Addendum Number: 03

Addendum Issue Date: April 28, 2025

Project Name: Robinson Washington Elementary
Renovation & Addition

Project Number: 02401781.001

Scale: NOT TO SCALE

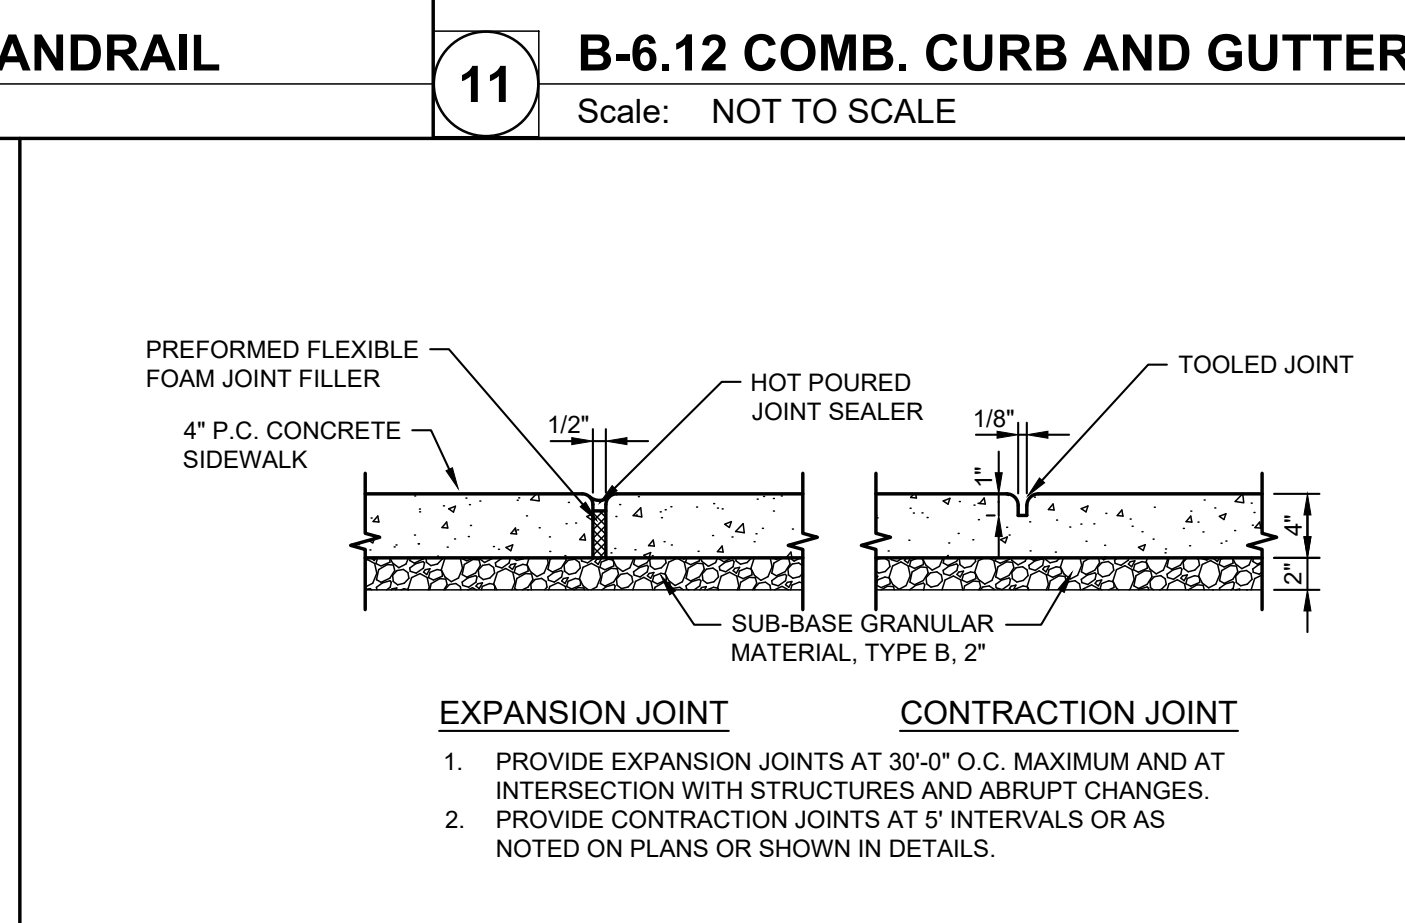
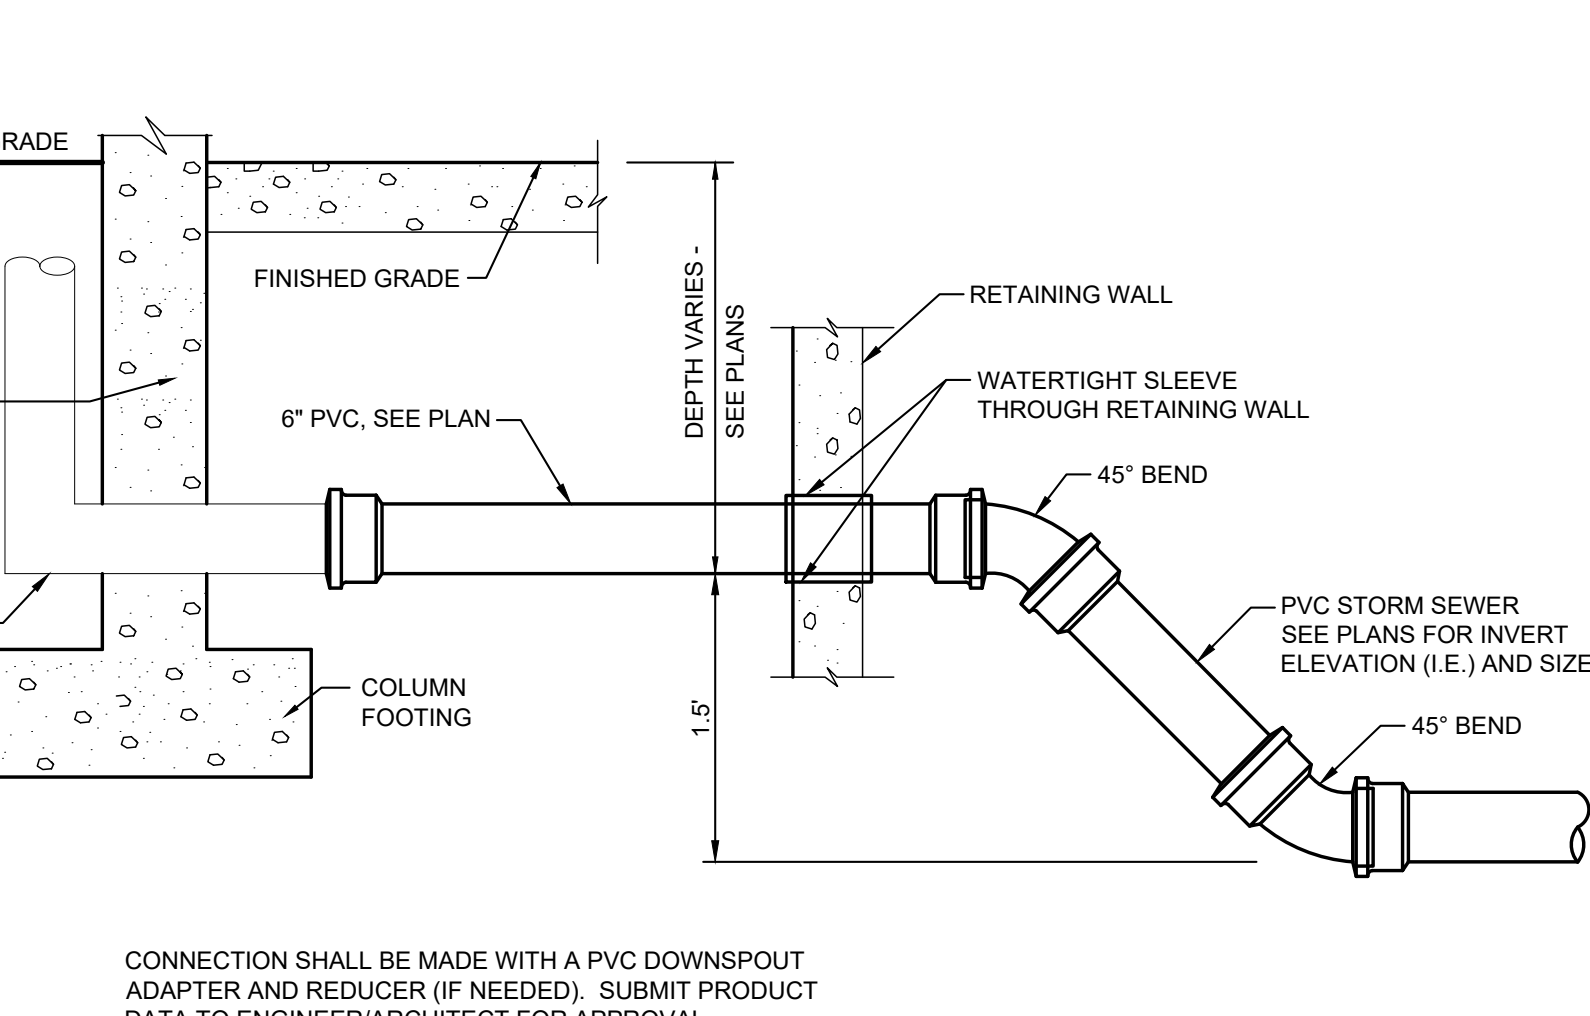
1. C1.1 – SITE & UTILITY PLAN
 - a. REMOVE color black specified for handrails/guardrails.
 - b. ADD note that handrail/guardrail color will be selected by the Owner and Architect.
2. C1.2 – SITE DETAILS
 - a. REVISE handrail material and color on Detail 1.
 - b. REVISE guardrail material and color on Detail 2.
 - c. REVISE handrail material and color on Detail 3.
 - d. REVISE handrail material and color on Detail 10.
3. S3.2 – FOUNDATION DETAILS
 - a. ADD protective steel coating below slab in Detail 11.
4. A5.9 – EXTERIOR DETAILS
 - a. ADD protective steel coating below slab to all the columns in the Gross Motor area.
 - b. ADD 2" rigid insulation to wrap around the columns.

SHEET TITLE:
GLAZING
ELEVATIONS -
WINDOW GRAPHICS

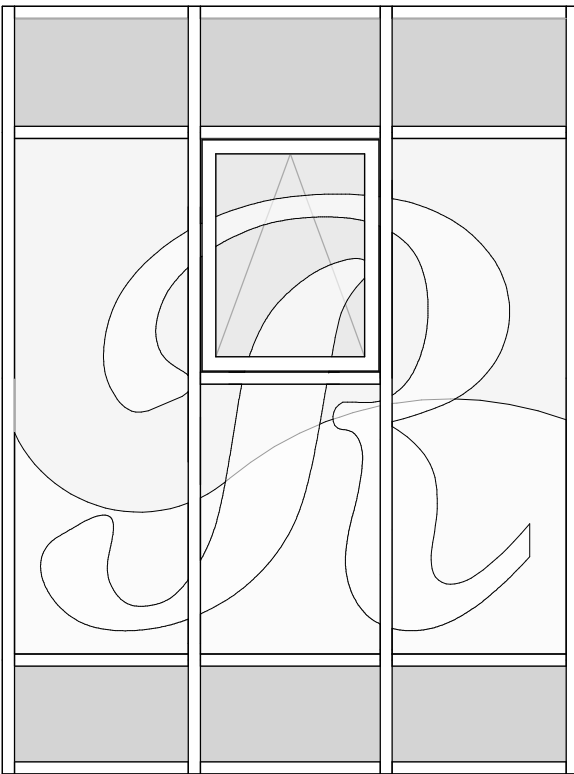
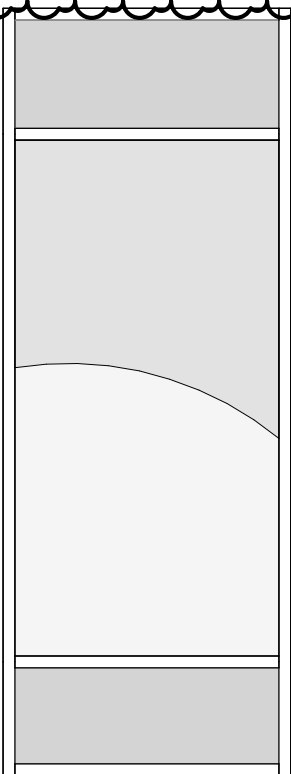
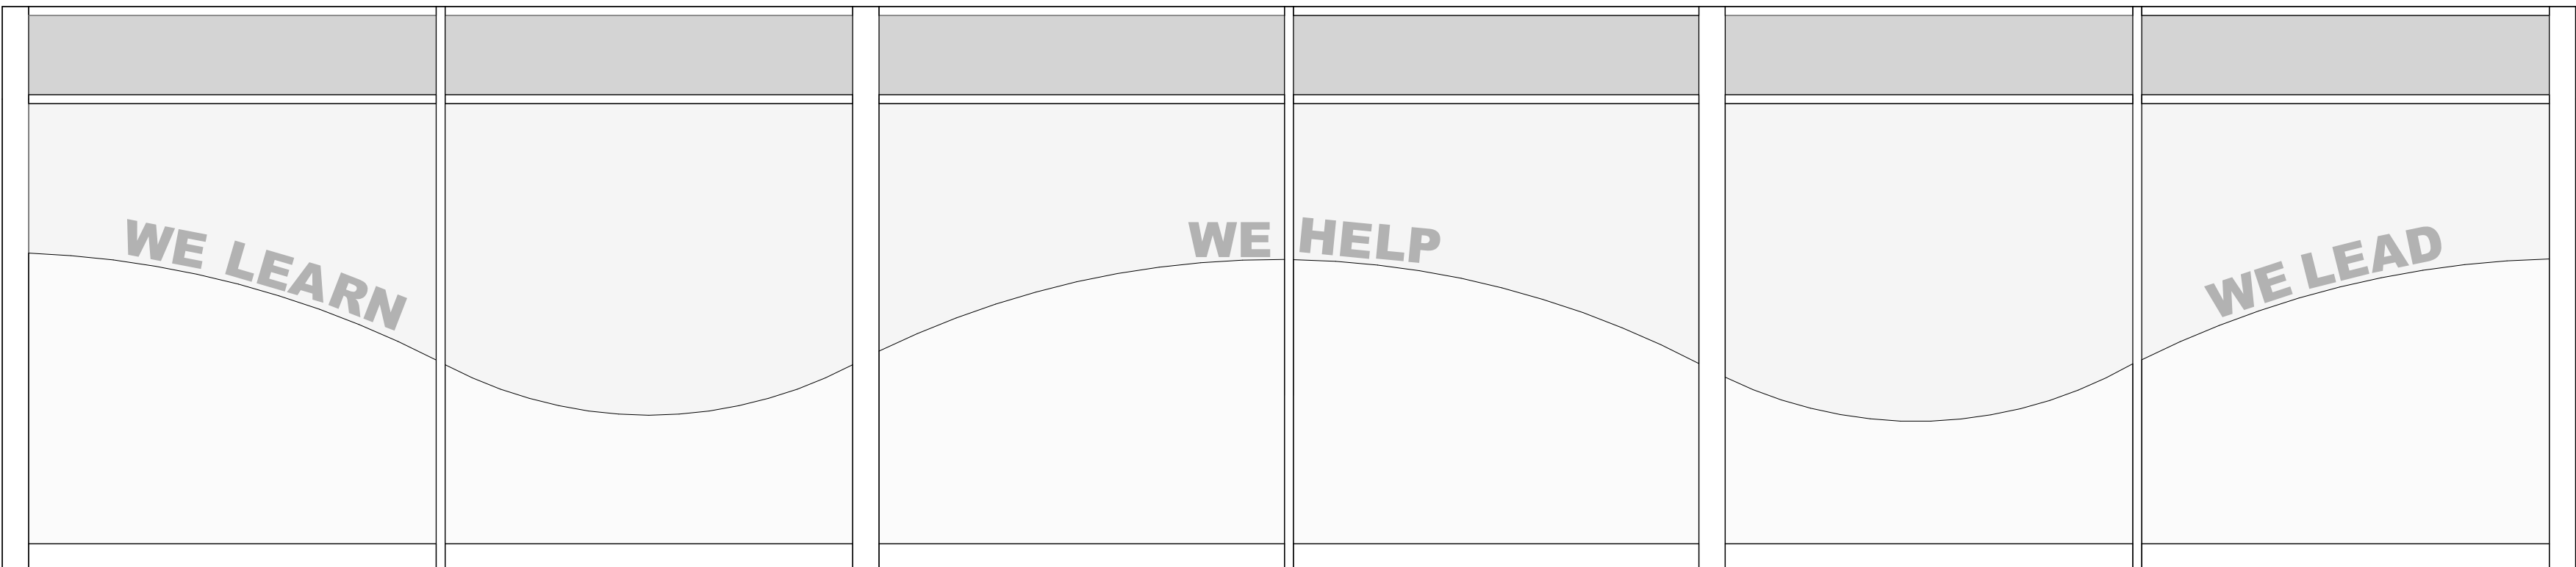
5. A7.31 – GLAZING ELEVATIONS - WINDOW GRAPHICS
 - a. REVISE note to include security and privacy films.
6. M1.1A – ENLARGED VENTILATION FLOOR PLAN – AREA A

ALL GLAZING MARKED AS IG-1, TO HAVE SECURITY AND PRIVACY FILM
APPLIED, SEE A7.3. ALL GLAZING CONTAINING SECURITY AND PRIVACY
FILM NOT SHOWN ON THIS SHEET IS TO BE OF A SOLID COLOR
SELECTED BY ARCHITECT AND OWNER. THIS SHEET IS ONLY TO SHOW
DESIGN INTENT FOR SECURITY AND PRIVACY FILM CONTAINING
ADDITIONAL GRAPHICS AND BRANDING.

ENLARGED VENTILATION FLOOR PLAN - AREA A

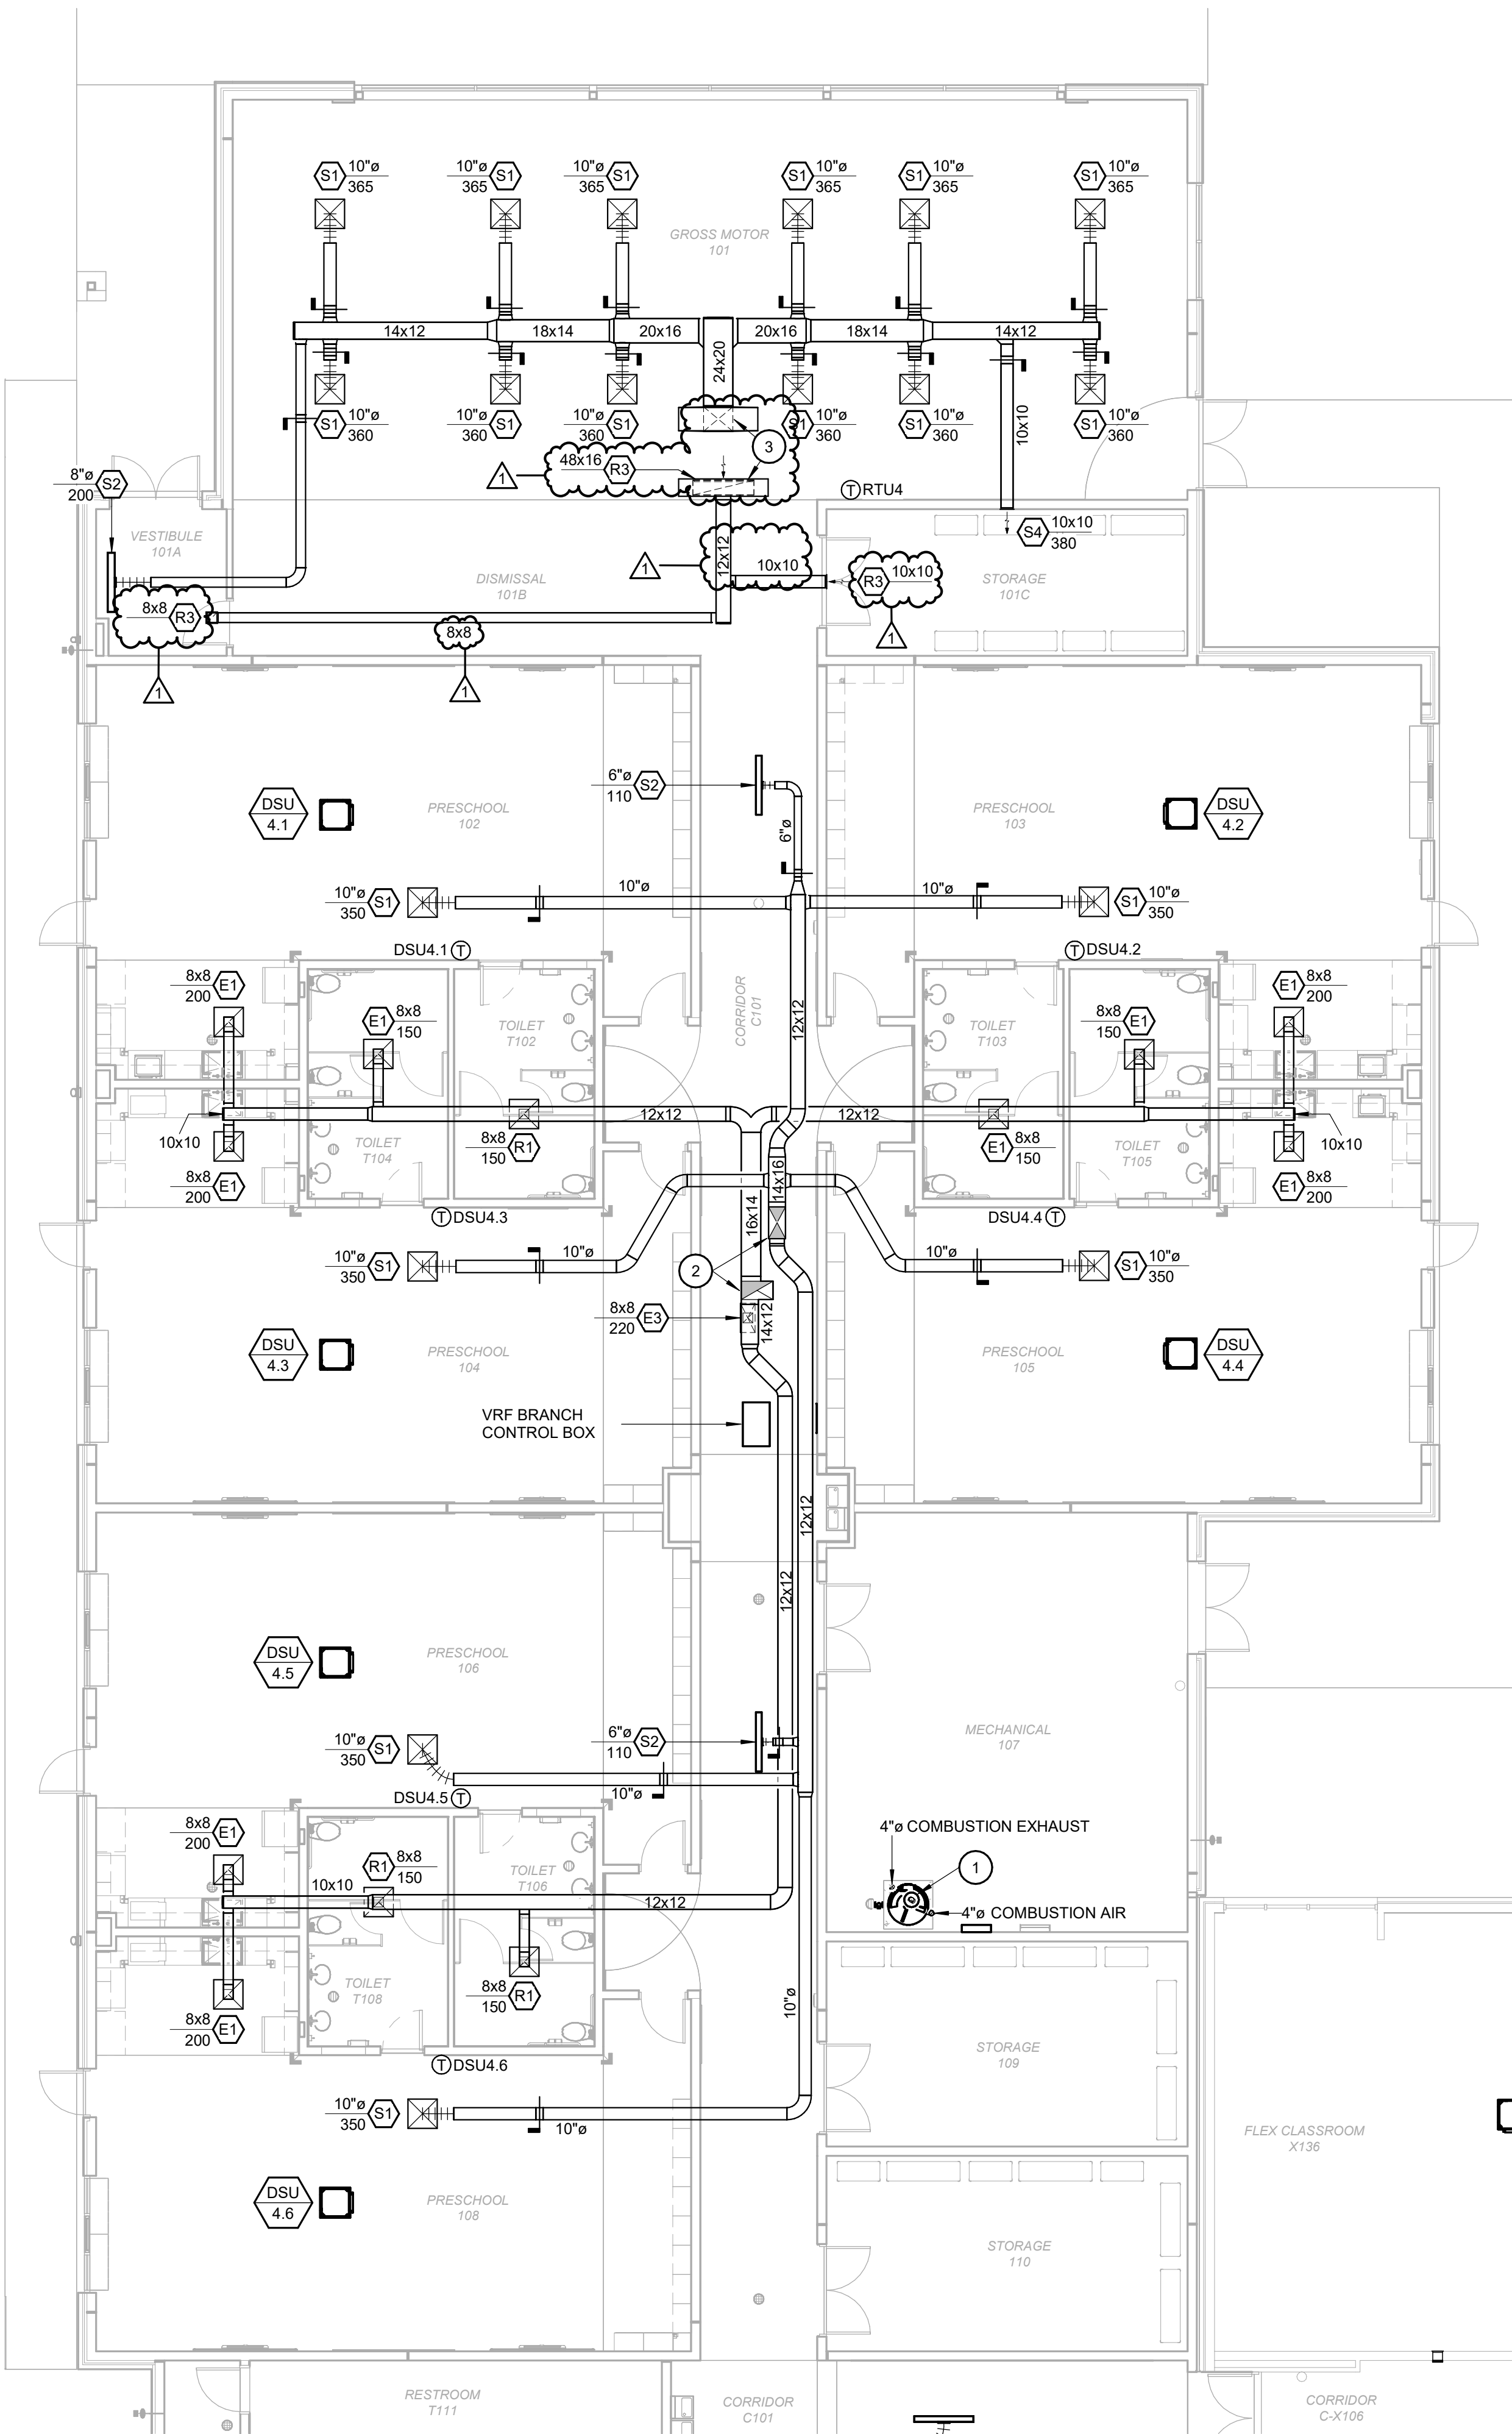
- a. REVISE ductwork.
 - b. ADD keynote #3.
 - c. REMOVE cfm values on air device tags for return air devices that do not require volume dampers.
7. M1.1B – ENLARGED VENTILATION FLOOR PLAN – AREA B
